RE: Field Issue of over-notched floor joists for Lot #152 Hawthorne Ridge – 3208 SW Arboridge Drive, Lee's Summit, MO 64082 – Permit # PRRES20215298

Findings: over-notched floor joist located under W.I. Closet.

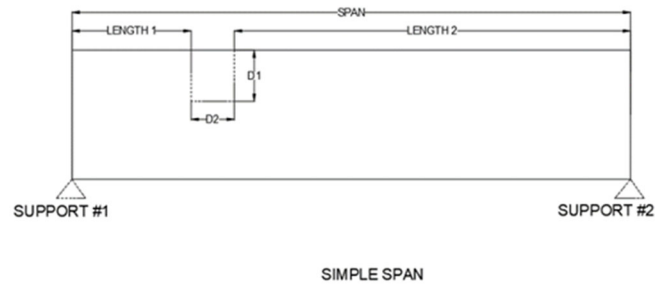
- D1 – 4' 6"
- D2 – 3' 6"
- Length 1 – 1' 7"
- Length 2 – 13' 2"
- Span – 14' 9" clear
- Support #1 – Foundation wall
- Support #2 – W8x10 Steel beam
- Location – Near foundation wall/ sump.
- Loading -
 - Dead = 15 psf @ 16" oc
 - Live = 40 psf @ 16" oc

- Header off notched floor joist with (2) #2- 2x10
- Blocking shall be installed if space of headered off area is greater than 2' in either direction.
